Docket No. 50-443
Docket No. 72-63
SBK-L-21023

Seabrook Station Radiological Emergency Plan (SSREP), Revision 77

Enclosure 1 to SBK-L-21023
Summary of Changes

Enclosure 2 to SBK-L-21023 Change Analysis Summary

FIGURE 6.1

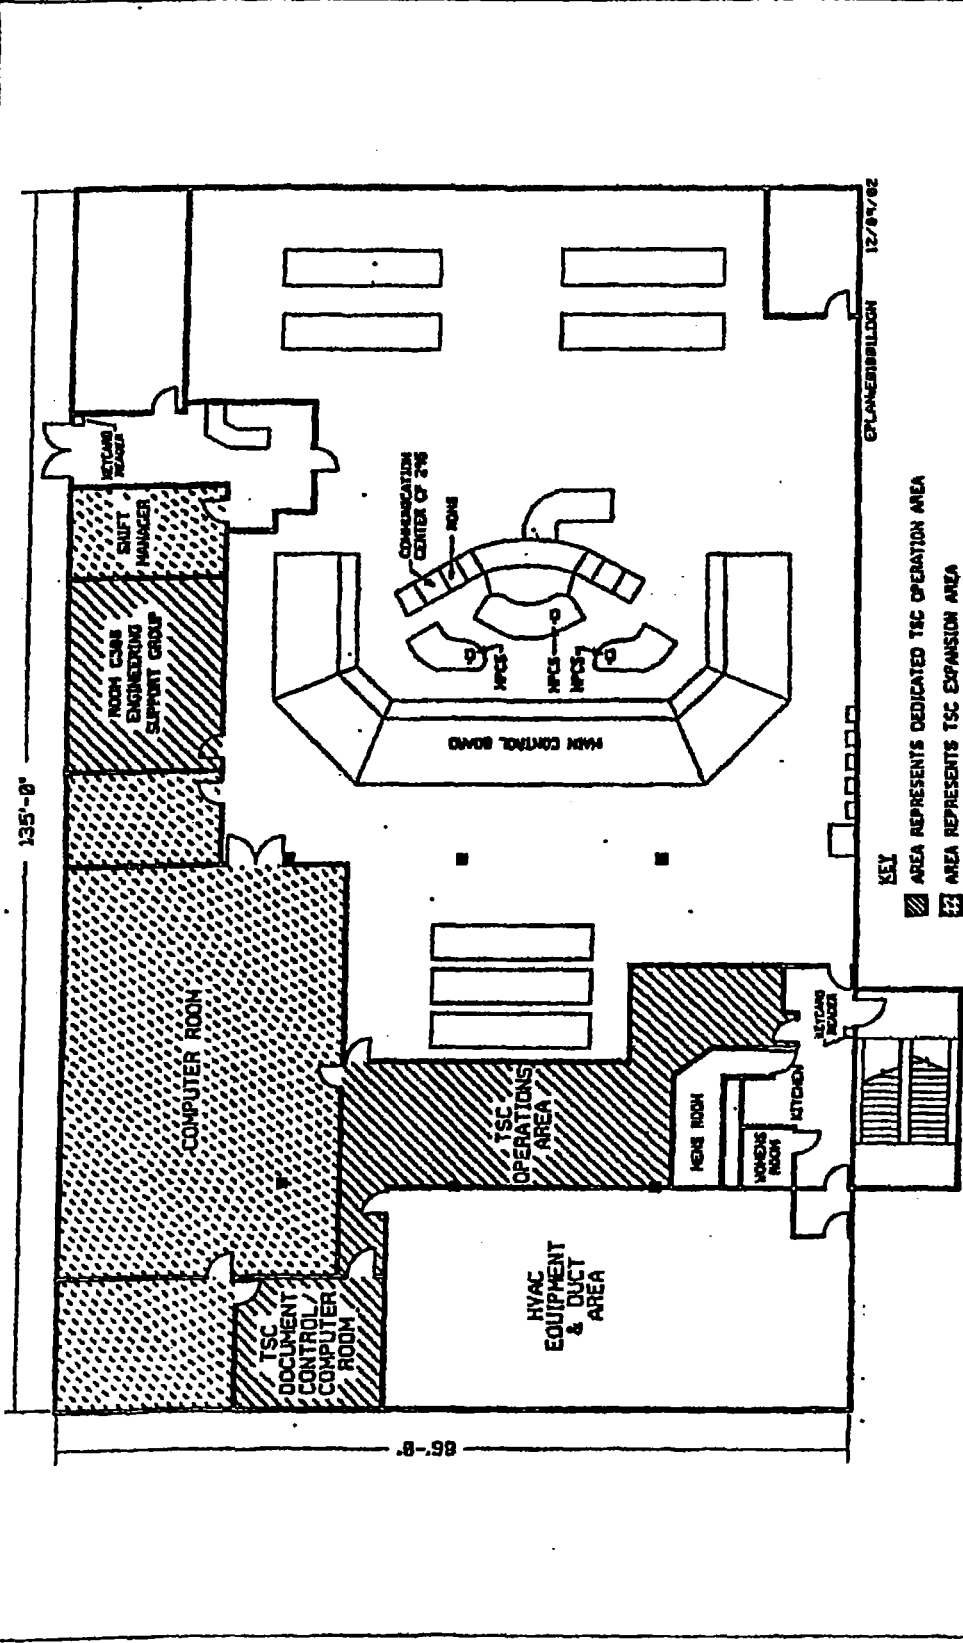
The EOF changed locations in 2013 and the SSREP was revised (AR 1721945) to reflect the new location in Portsmouth NH. This editorial change corrects the EOF location in Figure 6.1 that was inadvertently missed during the 2013 revision and is not associated with a planning standard.

Figure 6.1 - Corrected location of Emergency Operations Facility.

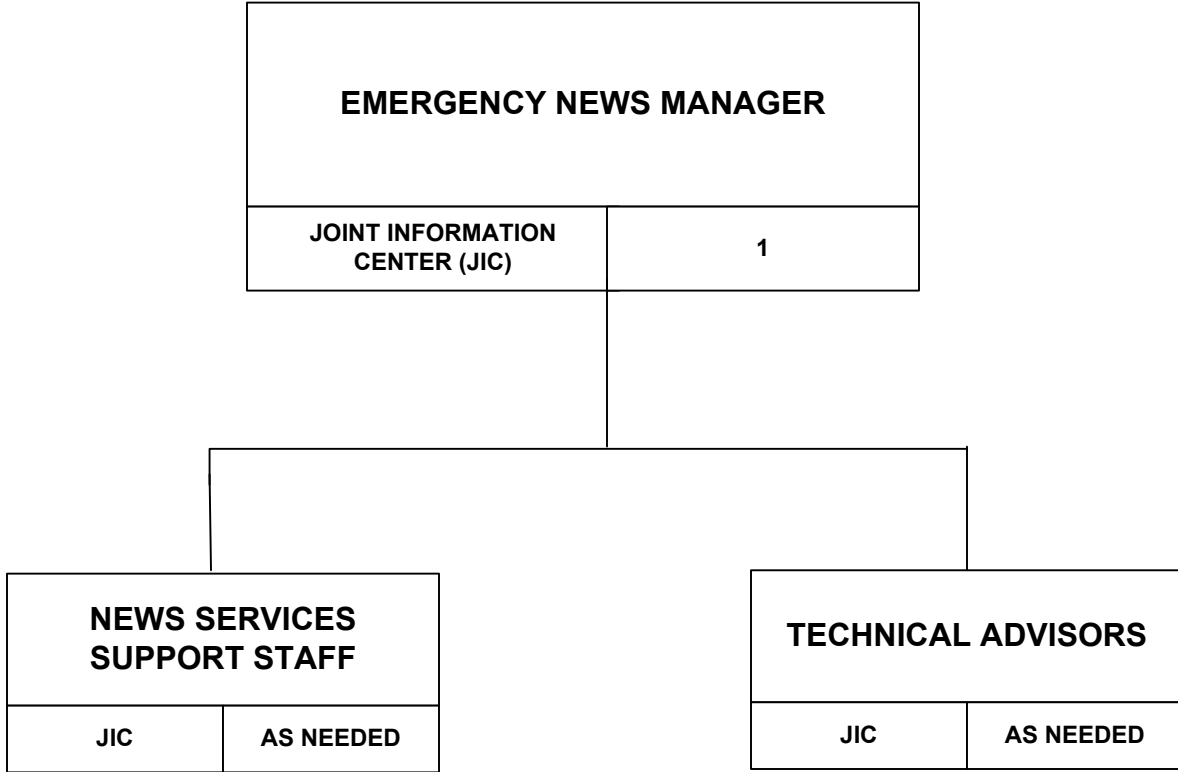
Revised the location of the Seabrook Station News Services from the Science and Nature Center to the Joint Information Center or as directed by the Emergency News Manager -

The Seabrook Station News Services activates during an Unusual Event. The Emergency News Manager may operate from any location and may request technical or administrative support at their discretion. The Science and Nature Center was viewed as a suggested facility to operate from; however the Joint Information Center is preferable since in the event of an emergency upgrade the Emergency News Manager would already be in their assigned facility. Only the Emergency News Manager is required to respond to the Unusual Event, while the Technical Advisor and Support Staff respond as needed. Figure 8.16 revised the number of Technical Advisors from 1 to “as needed” to match the Support Staff requirements.

Revised number of Technical Advisors to “as needed” -

Figure 8.16 – Revised the location of the Seabrook Station News Services from the Science and Nature Center to the Joint Information Center or as directed by the Emergency New Manager. Revised number of Technical Advisors to “as needed”.

Response may be to the Joint Information Center or as directed by the Emergency News Manager

SEABROOK STATION RADIOLOGICAL EMERGENCY PLAN	METHOD OF NOTIFICATION AND REPORTING INSTRUCTIONS FOR ONSITE PERSONNEL	
	SSREP REV. 67	Figure 9.1

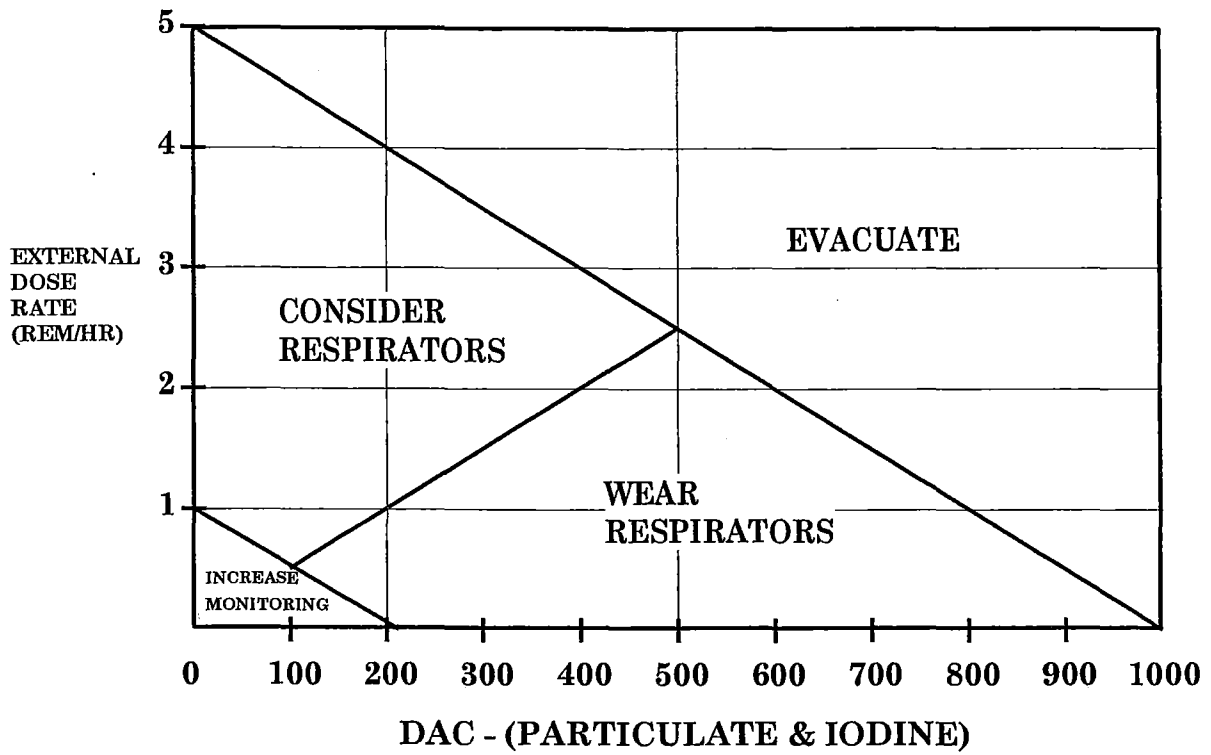
Currently during an Alert of higher emergency declared during normal work hours the Red Team reports to their facility while White Team congregates in the Assembly Area. White Team members then backfill any unfilled Red Team positions or transitions to staff the second shift. This change eliminates the Red and White Teams so that the emergency facilities will be immediately staffed, and all unassigned responders will then transition to the Assembly Area to be assigned to other shifts.

Section 2 & Figure 9.1 – Removed reference to Red and White teams.
